## RFP #845-19P Bear Park Phase II Contractor

**Addendum 003  
Issued April 1, 2019**

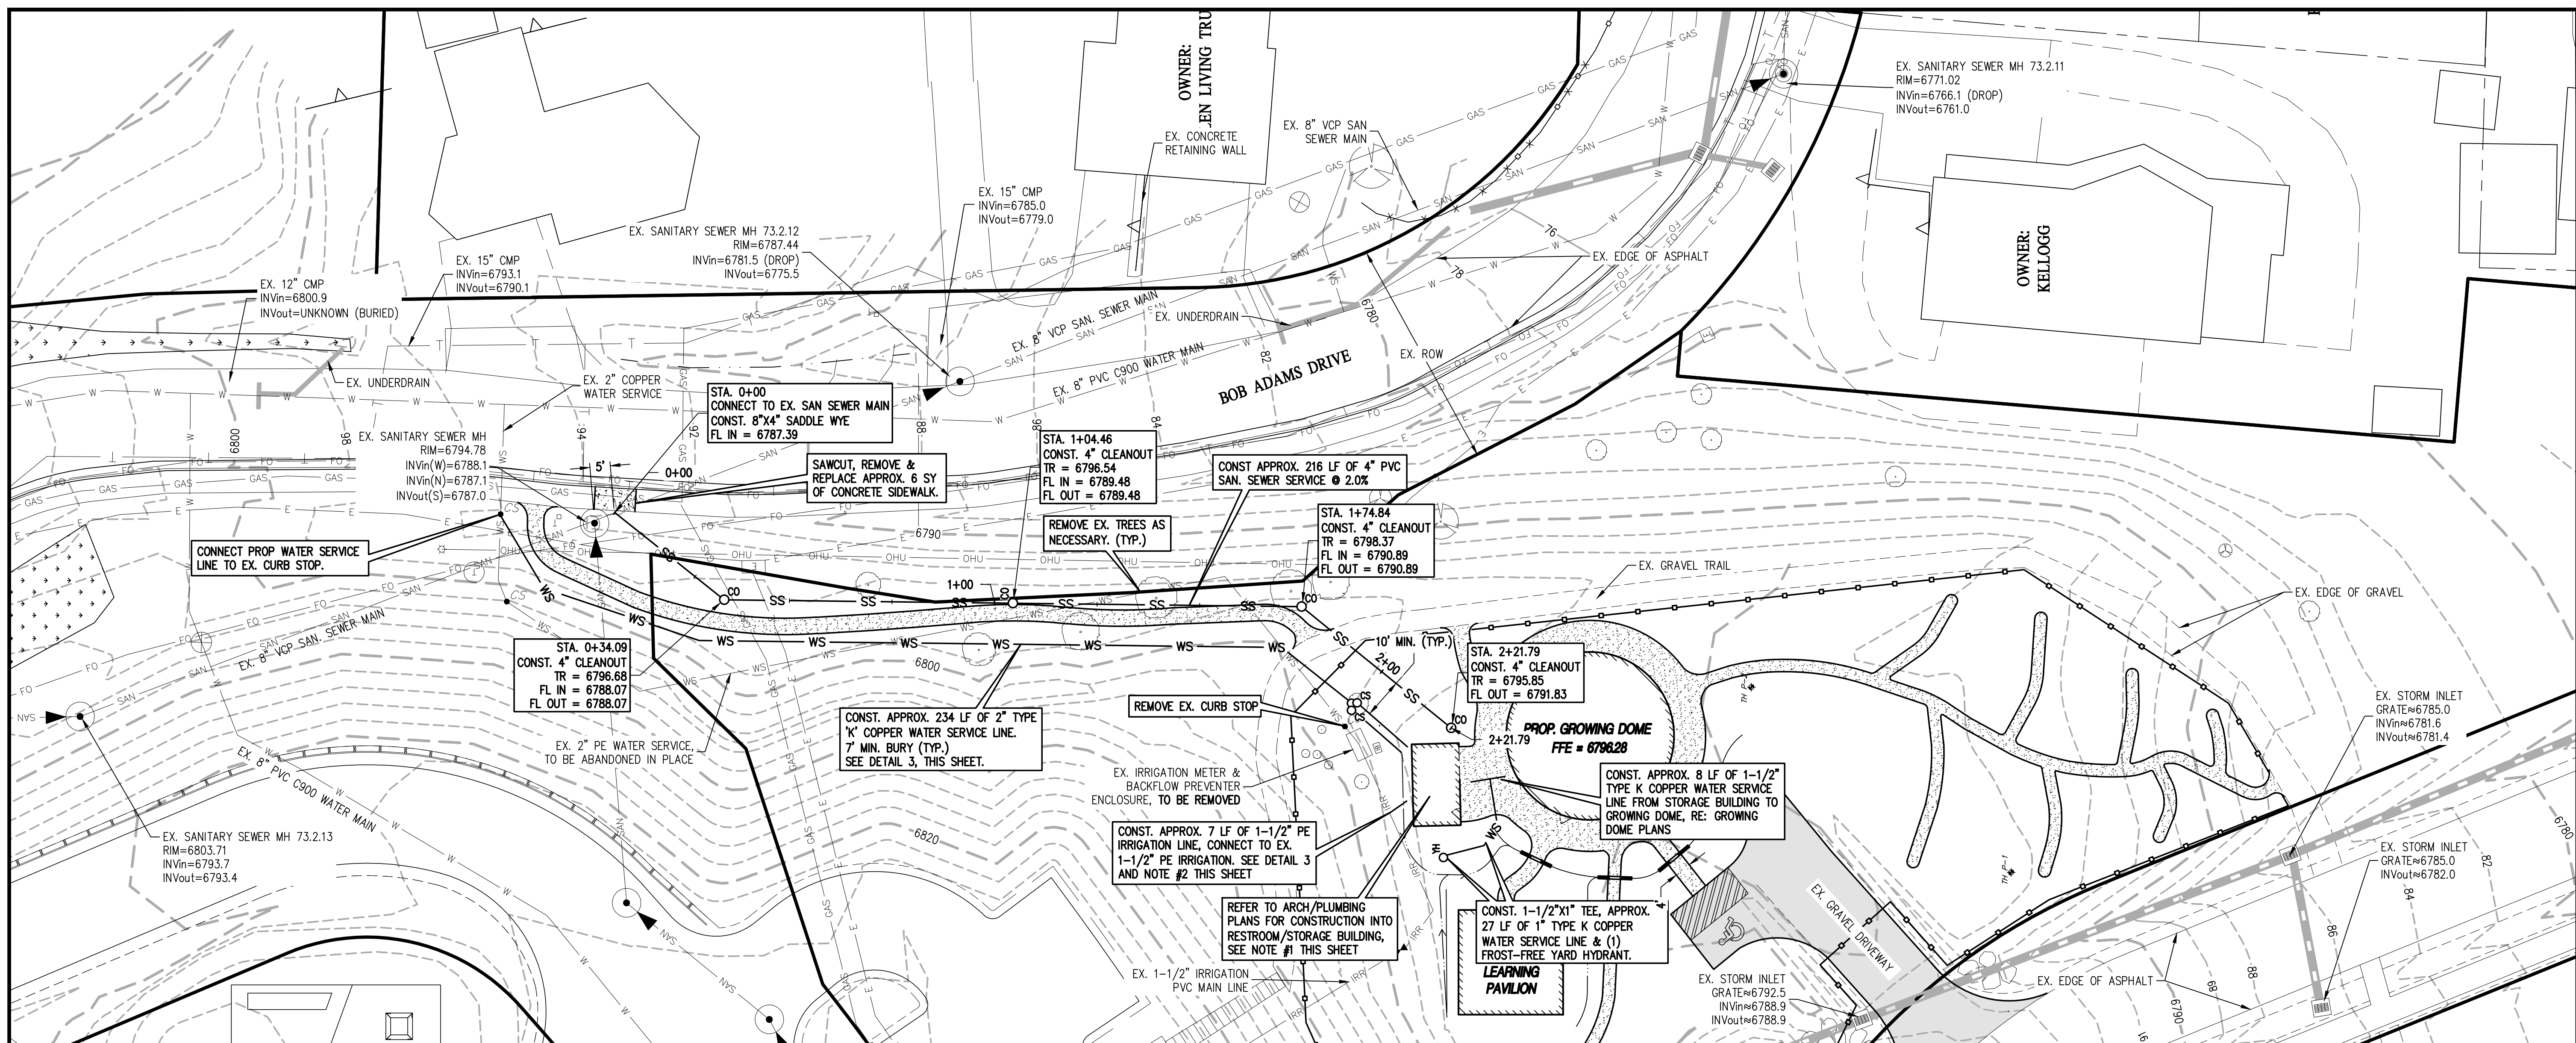
5. C6 calls for existing irrigation meter and backflow to be removed, is this Phase 1 or part of this bid.

11. Revision: A revision has been made to the configuration of the water service line just outside of the restroom/storage building. The 2" water service line will split into a 3/4" domestic service for the bathroom and 1-1/2" irrigation service. A revised Utility Plan (Sheet C6) and a revised Restroom/Storage Floorplan are attached to this addendum to detail this change.

See Revision item #12. The Phase 2 contractor will be responsible to remove the existing irrigation meter and backflow and enclosure once the restroom plumbing is complete and permanent service connection is made. See Water Service Detail & Notes on revised Utility Plan Sheet C6.

**WATER SERVICE LINE NOTES:**

- CONTRACTOR SHALL LEAVE EXISTING IRRIGATION ENCLOSURE INCLUDING METER, BACKFLOW PREVENTER, ETC. IN PLACE DURING INITIAL WATER SERVICE INSTALLATION AND INSPECTION. AFTER CITY UTILITIES APPROVES NEW SERVICE LINE, THEN CONTRACTOR SHALL MAKE A TEMPORARY CONNECTION TO THE EXISTING 2" PE IRRIGATION LINE. THIS WILL ALLOW CMC TO CONTINUE IRRIGATION OF PLANTER BEDS DURING CONSTRUCTION OF THE RESTROOM/STORAGE BUILDING.
- PHASE 2 CONTRACTOR SHALL REMOVE TEMPORARY CONNECTION AND IRRIGATION ENCLOSURE ONCE RESTROOM/STORAGE BUILDING IS COMPLETE AND CONNECT TO NEW METER, ETC. WITHIN THE BUILDING.
